# PLAN COMMISSION

## INTER-DEPARTMENTAL REVIEW COMMITTEE REPORT

### 50 YORKTOWN RING ROAD (YORKTOWN COMMONS PARCEL 2)

PC 16-18

*Front Yard Type I and Type II treatments, as shown in the Yorktown Commons Design Guidelines.*

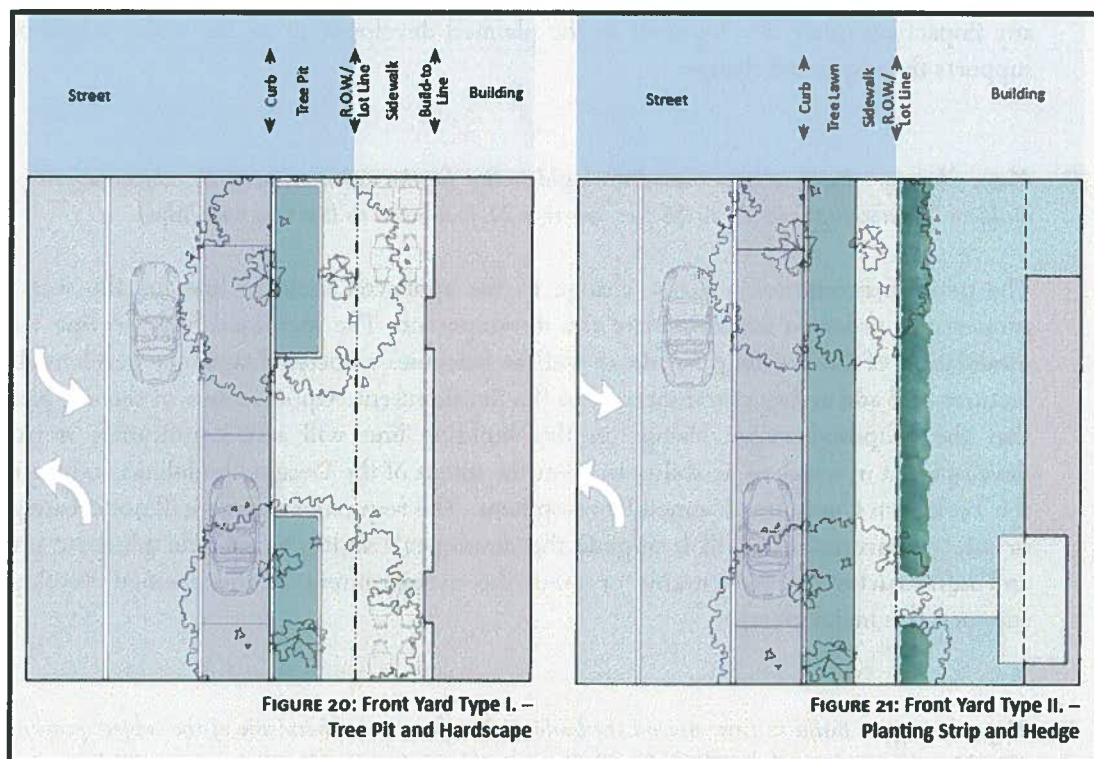
- F. *Major Change – Approve use of Front Yard Type II landscaping treatments along perimeter of the development where the Design Guidelines recommend Front Yard Type I landscaping treatment.*

The Design Guidelines require a combination of Front Yard Types for the perimeter of the subject property. Type II (planting strip and hedge) is mandated along the east and north sides of the site. Type I (tree pit and hardscape) is mandated along the west side of the site. The petitioner proposes to forego the use of Type I treatment and instead use the Type II treatment along all sides of the site where landscaping is required. The below graphic shows the differences between the two types.

Upon review of the landscape plan, staff finds that this proposed major change in the landscaping will not significantly impact the final development in terms of its ability to meet the intent of the Design Guidelines and the objectives of the Yorktown Commons Planned Development. Staff notes the use of the Type II treatment will result in more landscaping on the site, which is a benefit to the overall development. Moreover, the requested change will not create public health or safety concerns, nor will it impede the developer's ability to provide adequate public utilities and infrastructure improvements or meet the overall intent of the planned development. Staff supports this major change.
